Project
OLD CONNAUGHT PHASE A1 LRD

The purpose of the Stormwater Impact Assessment Report is to provide details of the Storm water elements associated with the proposed development at Lands at Allies River Road, Old Connaught, Co. Dublin.

WHERE TREE PIT SETBACK BEHIND RAISED PATH OR VERGE
Scale at A1 1:25
Scale at A3 1:50

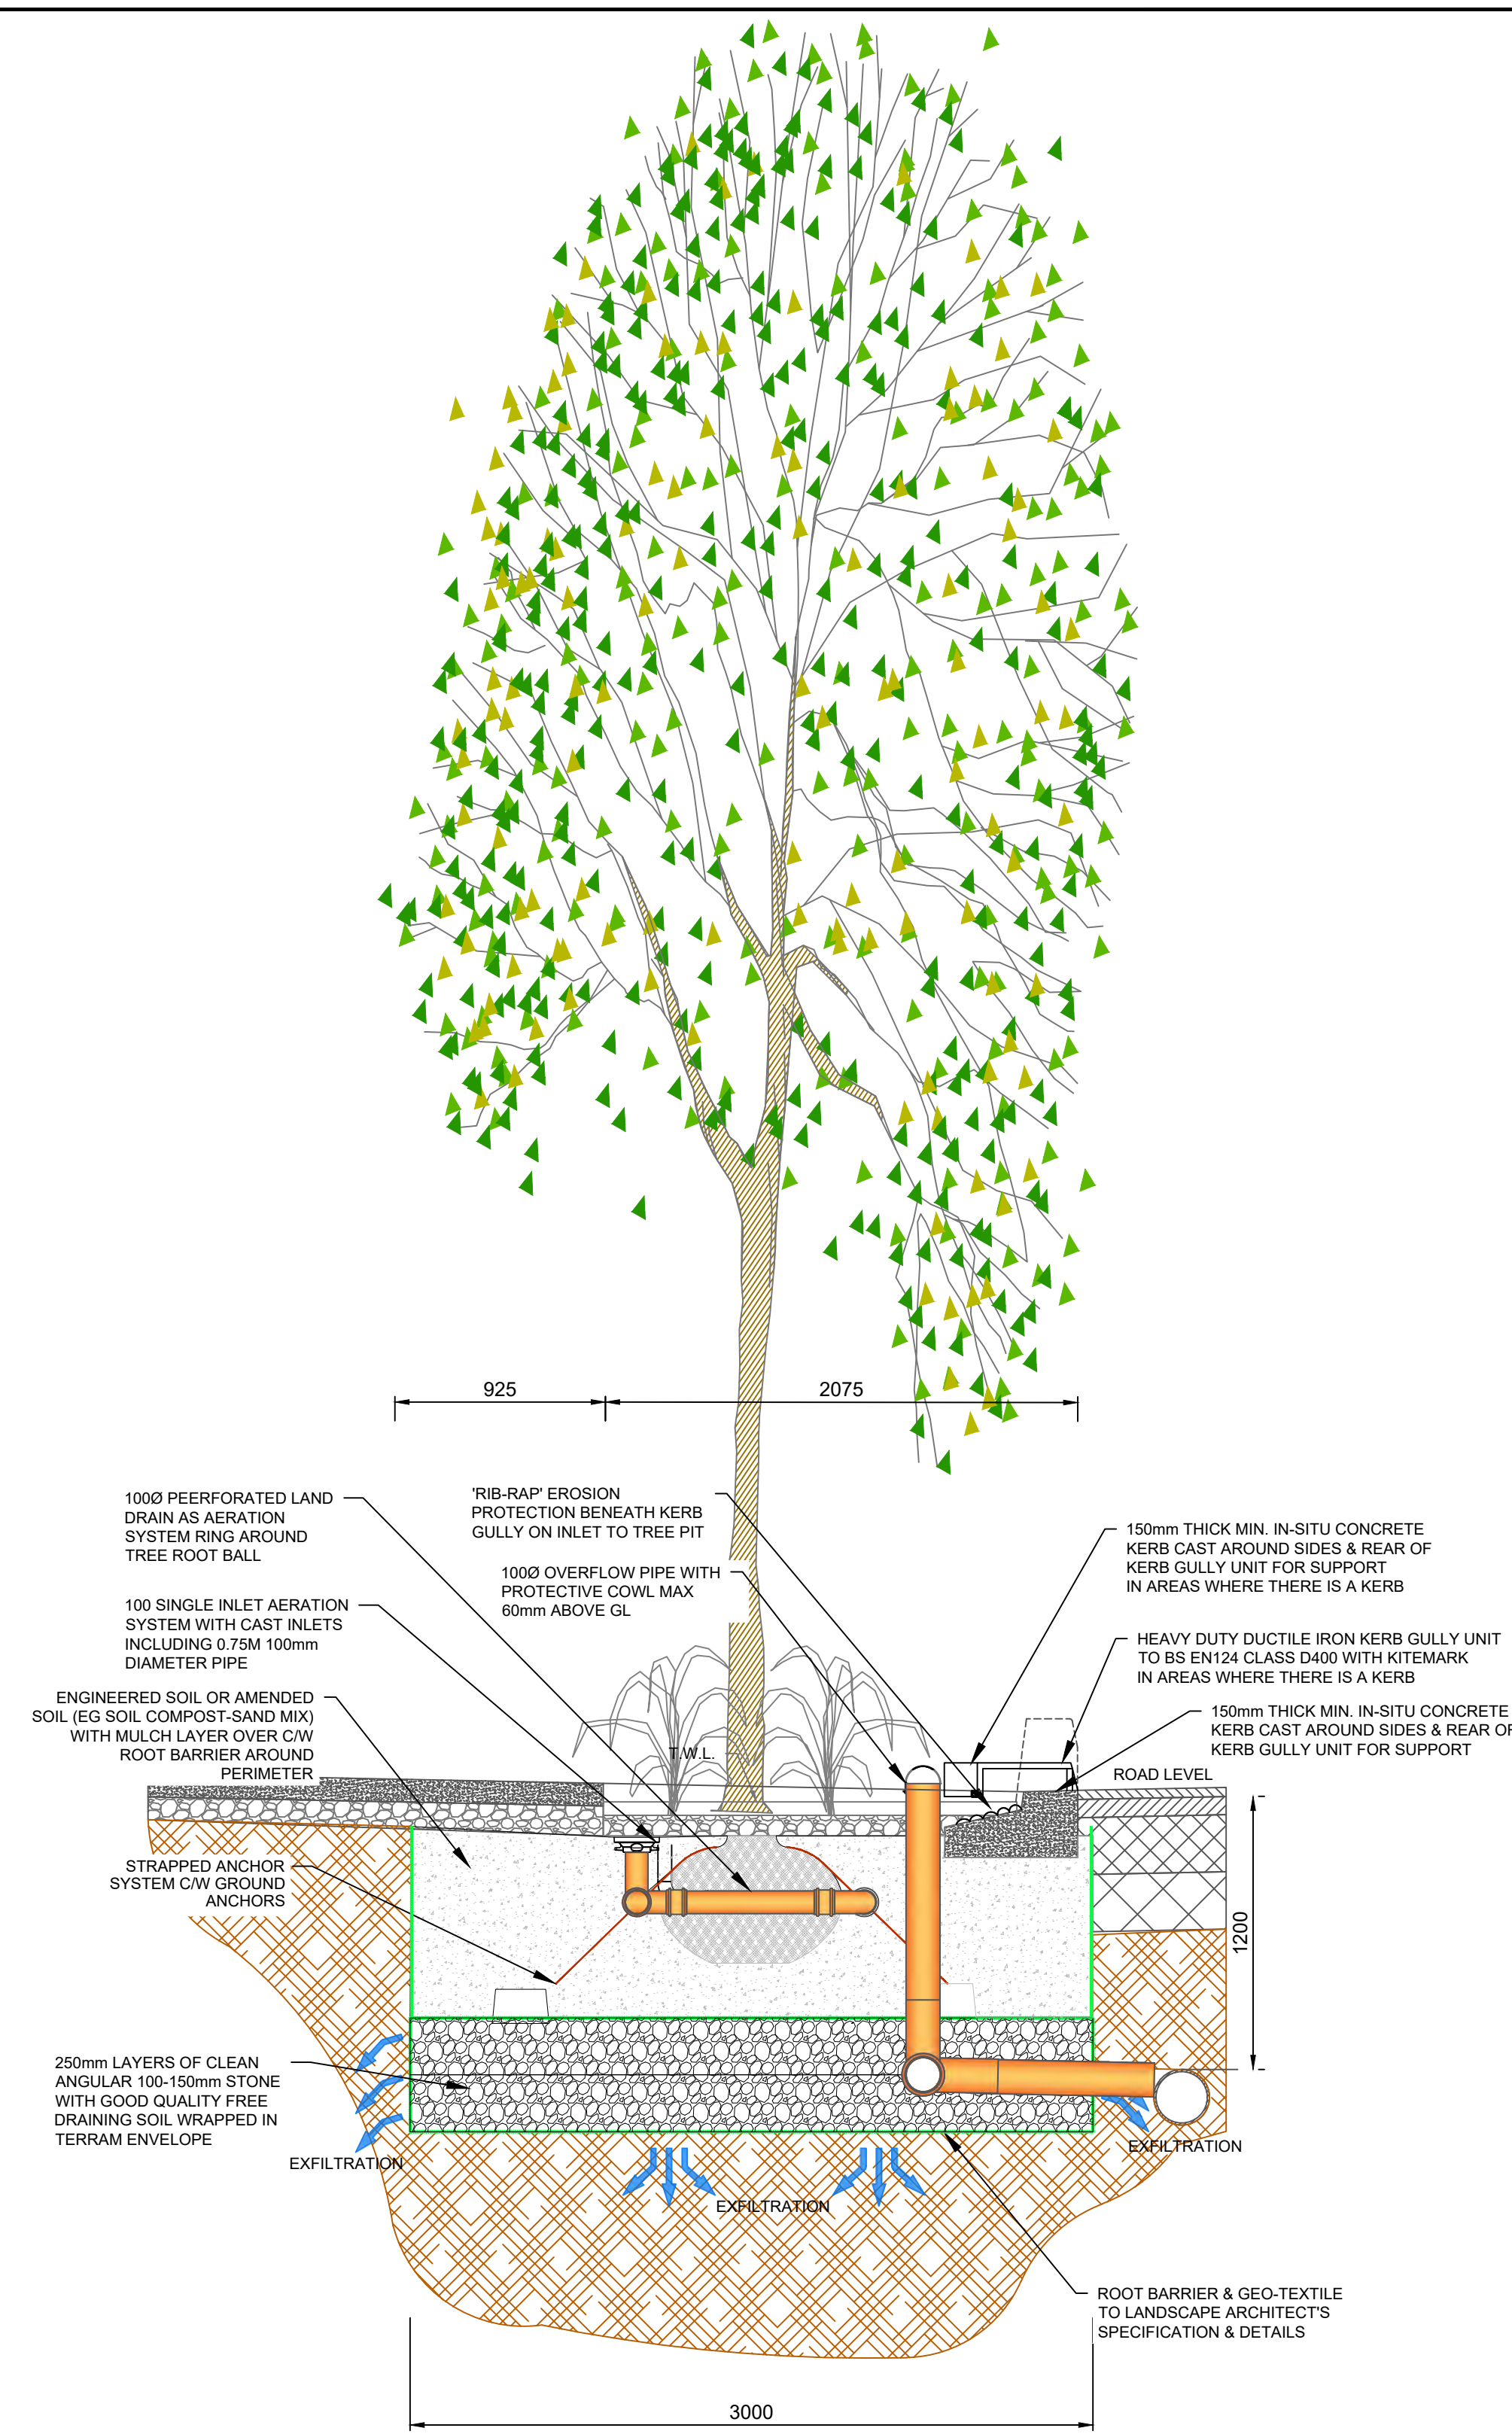
Problem: From the 'Proposed Storm Drainage Overall Plan', some tree pits appear to be standalone drainage systems with no connectivity to the surface water network. However, the Typical SuDS Details drawing indicates these features with overflow systems/outlet pipes.

2.6	Yes	Yes	The recommendation has been incorporated into the design, and the tree pit drainage connectivity and overflow arrangements are now clearly shown on the revised drawings issued with the resubmission. Please refer to drawings ATK-ZZ-ZZ-DR-CE-900501 Proposed Storm Drainage Layout - Sheet 1 ATK-ZZ-ZZ-DR-CE-900502 Proposed Storm Drainage Layout - Sheet 2	Yes

PROPOSED TANK A 1350M³ CHAMBER LAYOUT PLAN

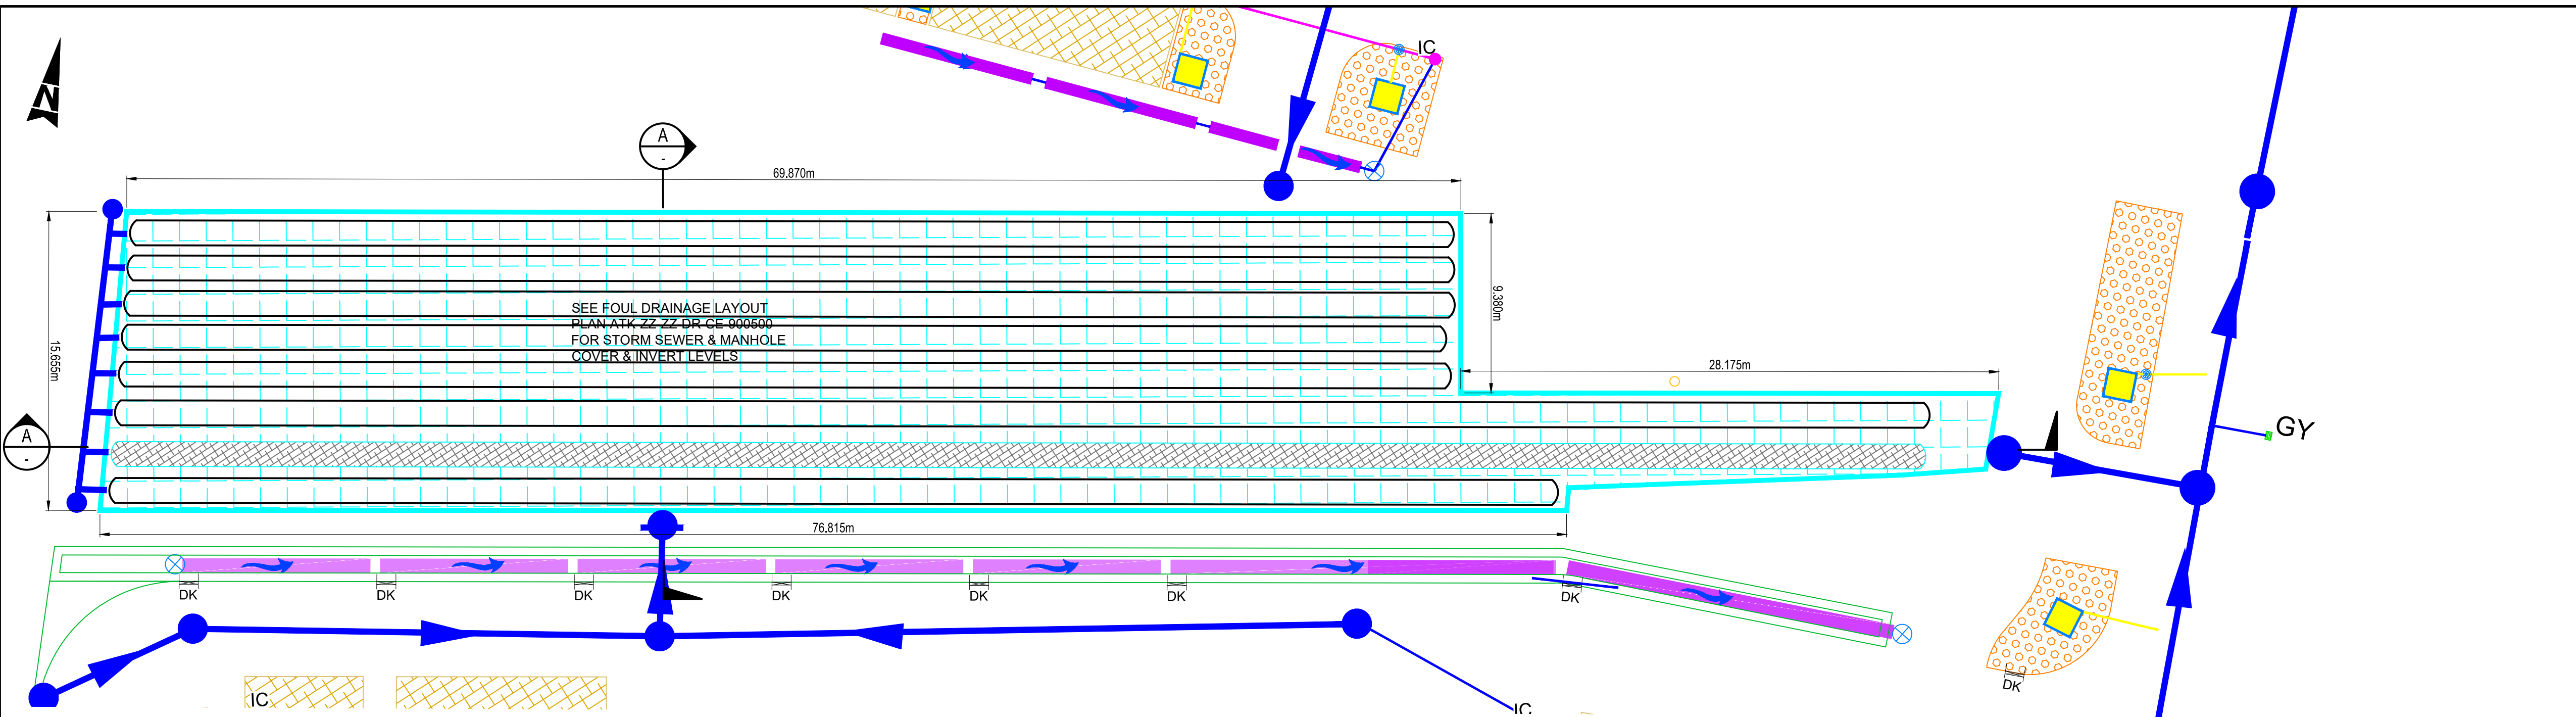
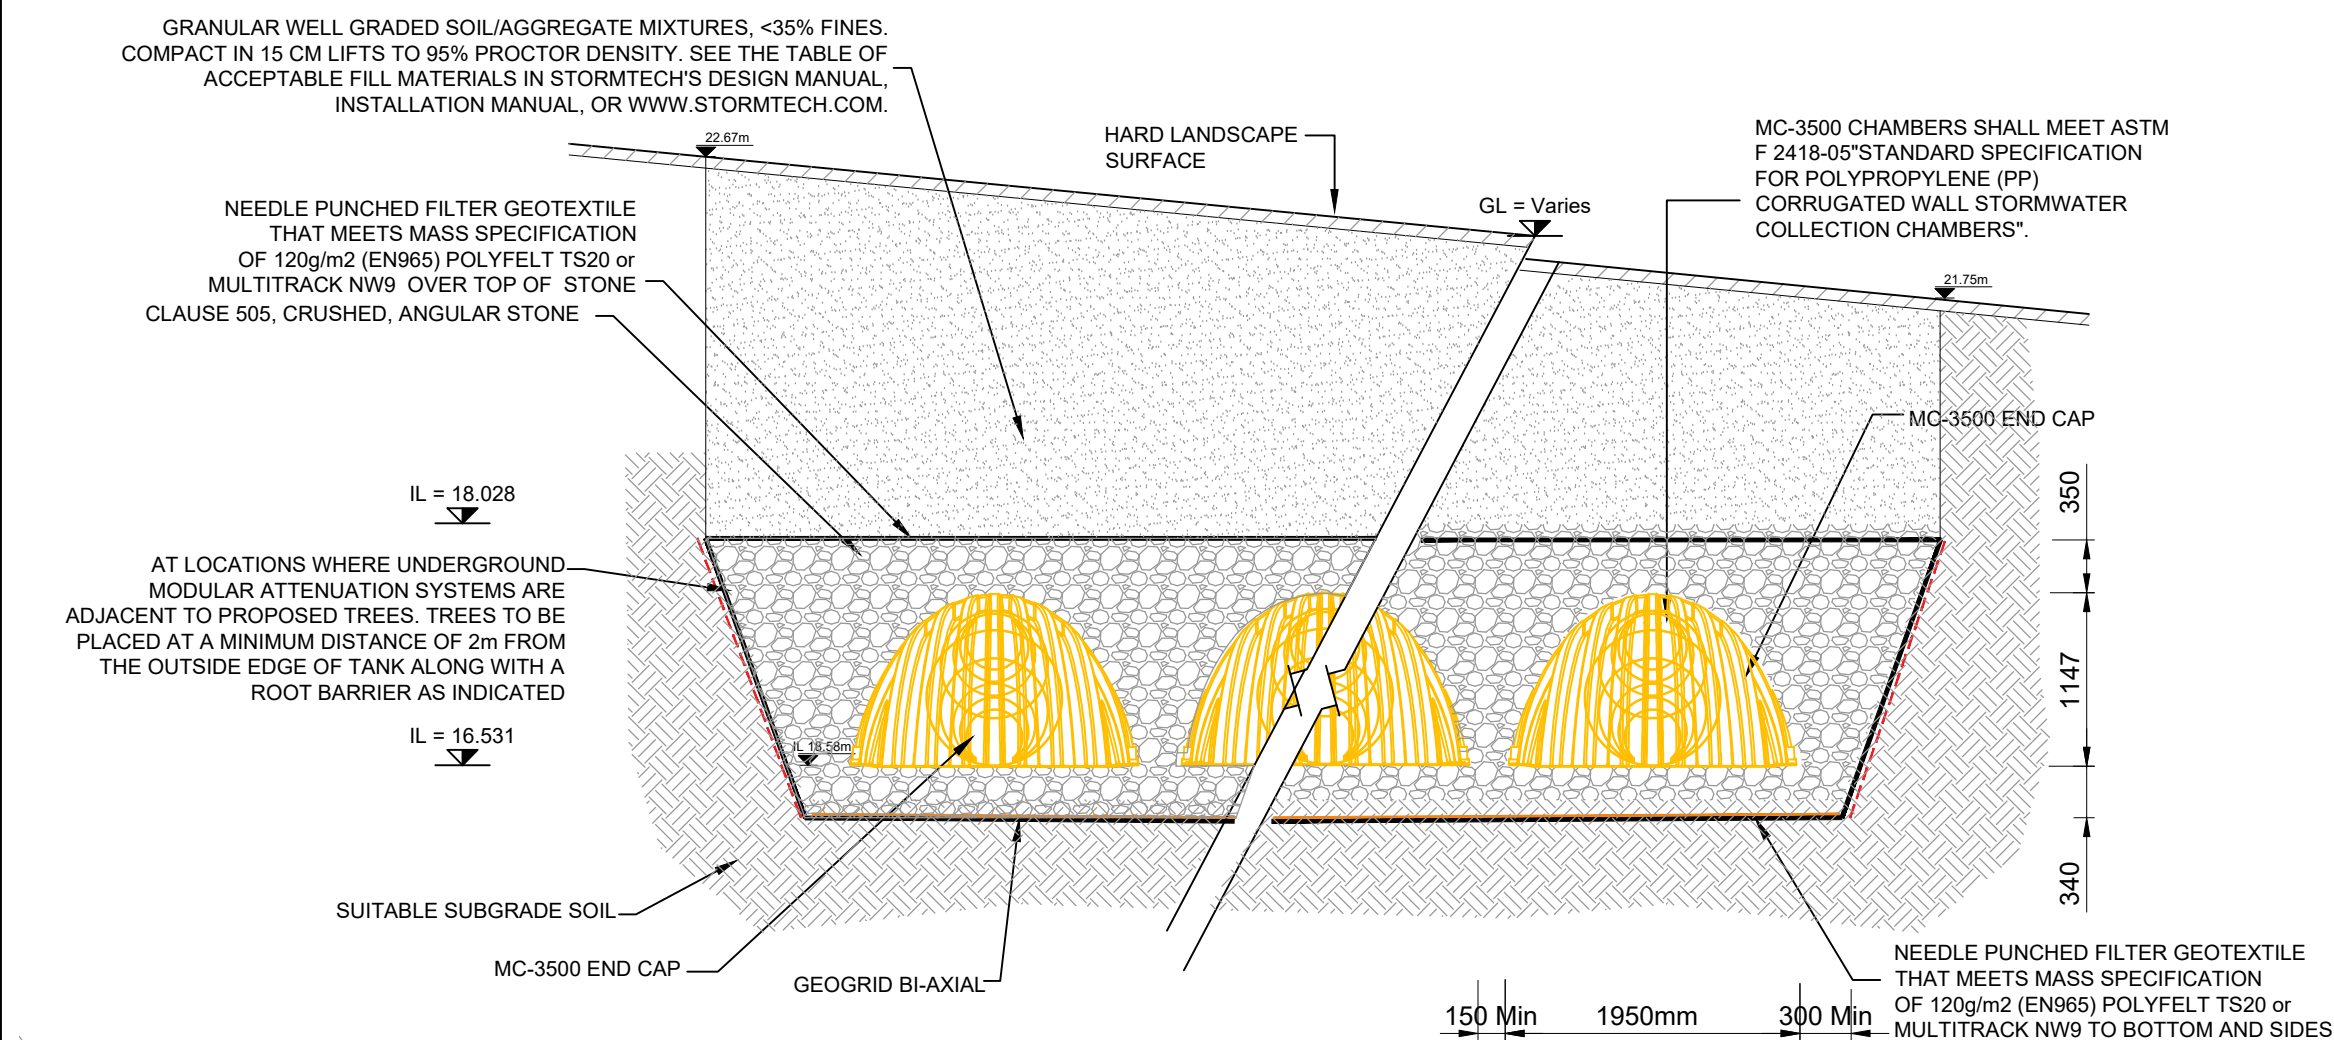
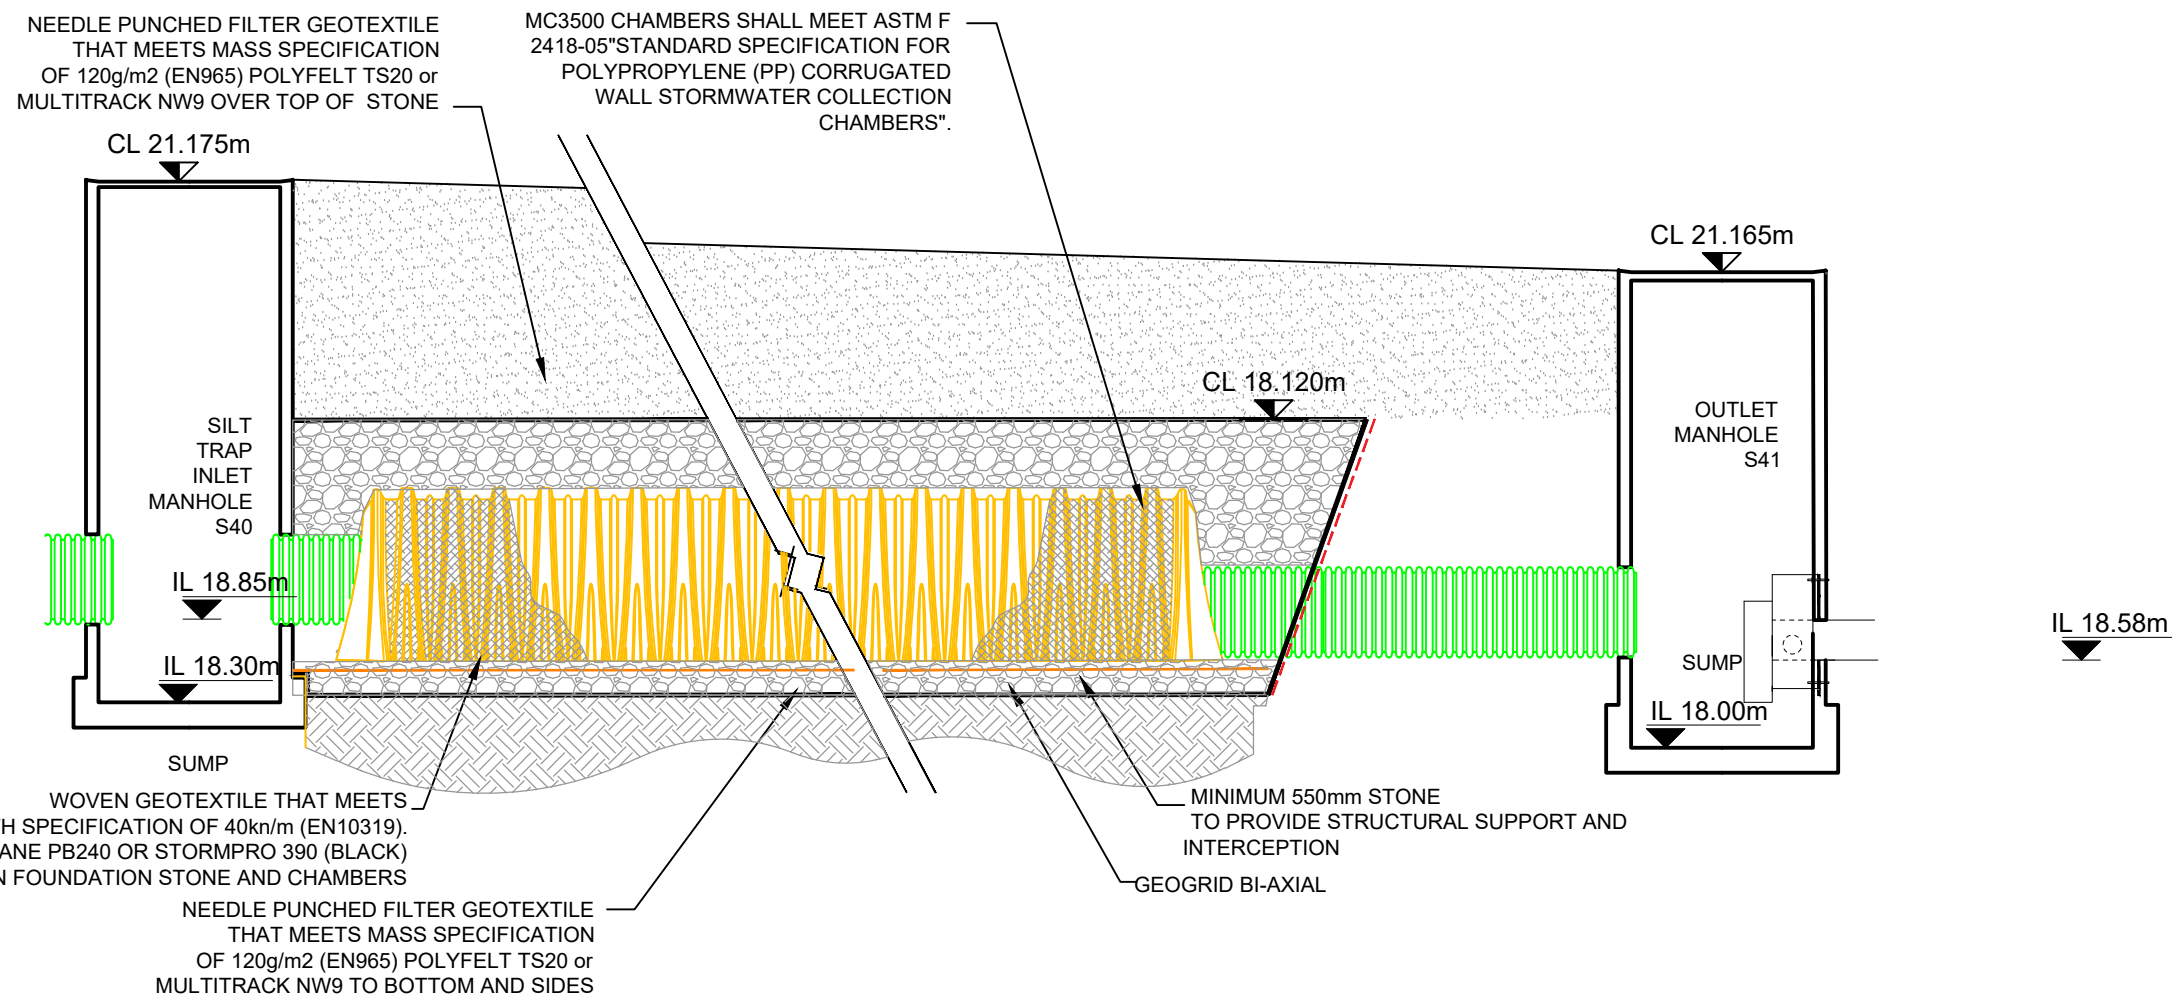
Problem: The 'Standard Construction Details' drawing shows manholes S40 and S41 as the inlet and outlet points of the proposed Attenuation Tank A. However, these manholes are shown as part of the future development network in the 'Proposed Storm Drainage Overall Plan'.

2.9	Yes	Yes	The recommendation has been taken on board. The drawings have been updated to ensure consistency between the <i>Standard Construction Details</i> drawing and the <i>Proposed Storm Drainage Overall Plan</i> . The revised drawings ATK-ZZ-ZZ-DR-CE-900501 Proposed Storm Drainage Layout - Sheet 1 ATK-ZZ-ZZ-DR-CE-900502 Proposed Storm Drainage Layout - Sheet 2, ATK-ZZ-ZZ-DR-CE-909008 Standard Construction Details Sheet 8 reflect these updates have been submitted as part of the updated design package.	Yes
